MDI Comments Application Perspective

**Indianapolis, Indiana
September 2019**

- **802.3 D3p3 MDI comments application perspective**

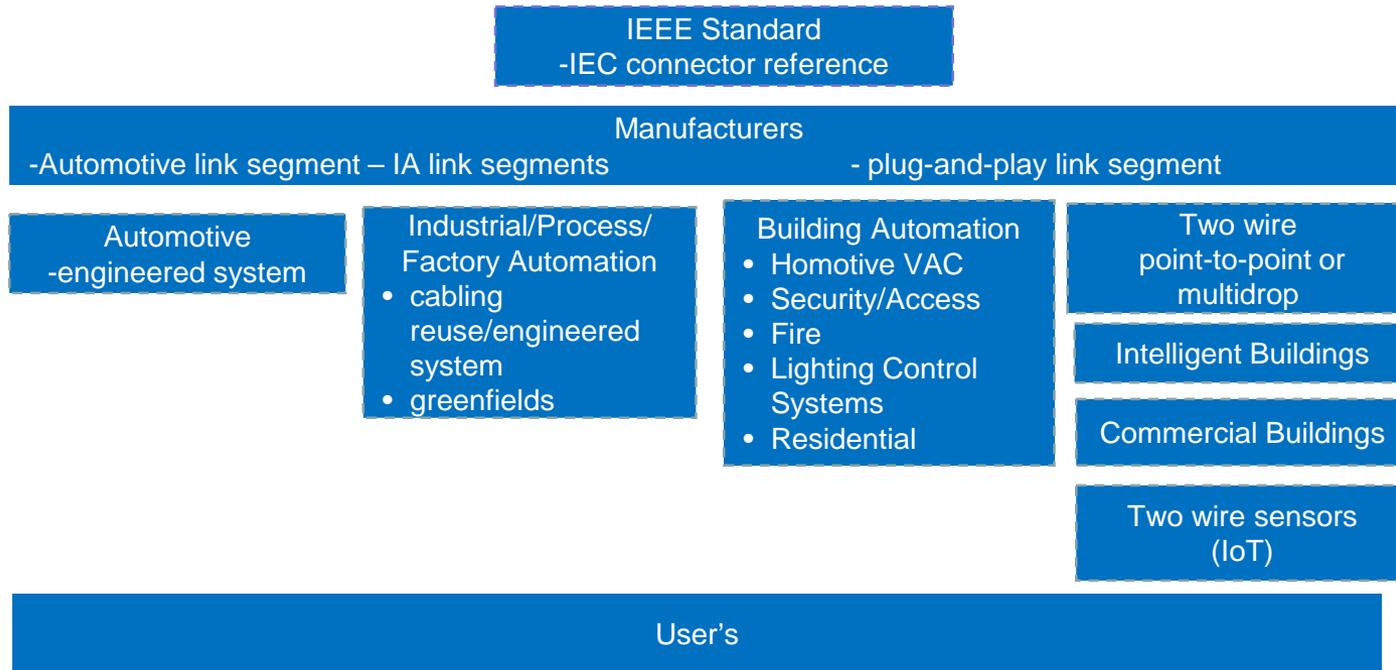
Specific systems or applications can use connectors or terminals, in addition to those listed below, that support the link segment specification defined in 146.7.

Connectors meeting the requirements of IEC 63171-1 or IEC 61076-3-125 may be used as the mechanical interface to the balanced cabling. The plug connector is used on the balanced cabling and the MDI jack connector on the PHY. The IEC 63171-1 plug and jack are depicted (for informational use only) in Figure 146-26 and Figure 146-27 respectively, and the mating interface is depicted in Figure 146-28. The IEC 61076-3-125 plug and jack are depicted (for informational use only) in Figure 146-29 and Figure 146-30 respectively and the mating interface is depicted in Figure 146-31. The assignment of PMA signals to connector contacts for PHYs are given in Table 146-8. These two connectors may be used, with adaptations if needed, for electromagnetic classifications for the link segment given in Table 146-7. These connectors should support link segment DCR characteristics for 1.02 mm (18 AWG) to 0.40 mm (26 AWG) in Table 146B-1.
